ZONING AMENDMENT,
PLANNED UNIT DEVELOPMENT &
SUBDIVISION STAFF REPORT

Date: September 20, 2007

<u>NAME</u>	Crossroads, LLC
<u>SUBDIVISION NAME</u>	UNO Subdivision
<u>LOCATION</u>	East side of Sollie Road, 800'± South of Shadow Creek Drive
<u>CITY COUNCIL DISTRICT</u>	District 6
<u>PRESENT ZONING</u>	B-2, Neighborhood Business and R-3, Multi-Family Residential
<u>PROPOSED ZONING</u>	R-3, Multi-Family Residential
<u>AREA OF PROPERTY</u>	1 Lot/34.4± Acres
<u>CONTEMPLATED USE</u>	<p>Subdivision approval to create a legal lot from a metes and bounds parcel, Rezoning from B-2, Neighborhood Business and R-3, Multi-Family Residential district, to R-3, Multi-Family Residential to eliminate split zoning in a one lot subdivision to allow a 384-unit residential apartment complex and Planned Unit Development Approval to allow a 20-building, 384-unit apartment complex on a single building site.</p> <p>It should be noted, however, that any use permitted in the proposed district would be allowed at this location if the zoning is changed. Furthermore, the Planning Commission may consider zoning classifications other than that sought by the applicant for this property.</p>

SITE PLAN

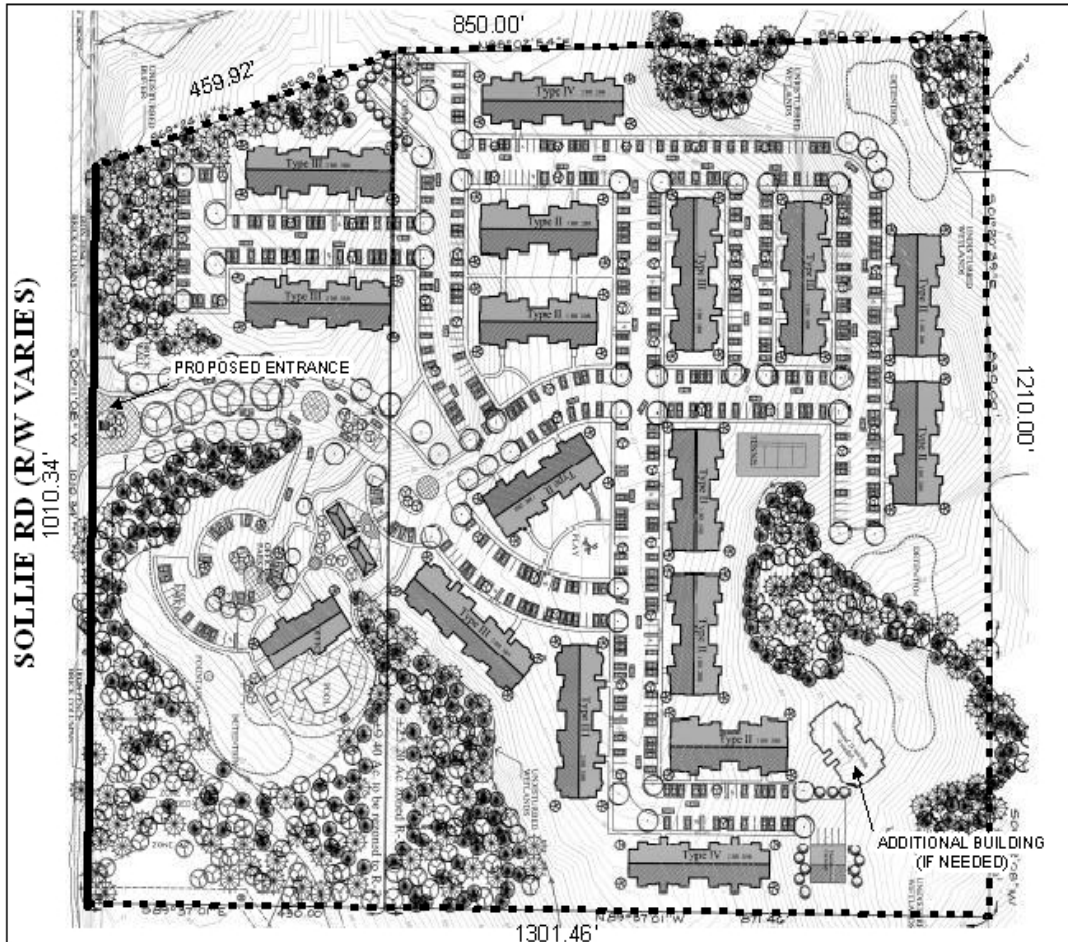
The site plan does not indicate the location of a stormwater detention basin, which may be required for the site due to new construction. A stormwater detention basin, sized to meet the requirements of the City's Storm Water Drainage Ordinance, must be indicated on the site plan if it is required. A note should be placed on the site plan, if approved, stating that maintenance of the detention basin common area, and any other common areas, are the responsibility of the development's property owners.

Conceptually, the development depicted on the proposed site/layout plan will minimize impacts to the potential residential and/or commercial development, especially with future development along Sollie Road. It should be noted, however, that there is no indication on the site plan regarding the perimeter treatment of the property; specifically if a fence and/or landscape buffer will be provided to minimize impacts to adjacent lower-density residential development to the North, East and South. A privacy fence and landscape buffer is recommended for development along these property lines. The applicant does illustrate an iron fence with brick columns along the Sollie Road frontage. Furthermore, generalized landscaping proposed for the development is

The vehicular circulation depicts a 24-foot wide parking and maneuvering areas. The site would access with Sollie Road and does illustrate a two-way, entrance with a landscaped median. However, depending on the Fire Department apparatus movement, the site may require two separate entrances. It should be noted that sidewalks are not illustrated, and would be required as this is developed.

Finally, the minimum building setback line required in Section V.D.9. of the Subdivision Regulations is not shown for the overall lot, but would be required on the Final Plat.

- 1) the submittal of the completed traffic impact study as required by Traffic Engineering;
- 2) depiction of the location of the dumpsters; and
- 3) the illustration of the buffering along the sides and rear of the development.

- 1) depiction of the 25-foot minimum building setback line;
- 2) the submittal of the completed traffic impact study as required by Traffic Engineering;
- 3) depiction of the location of the dumpsters; and
- 4) the illustration of the buffering along the sides and rear of the development.
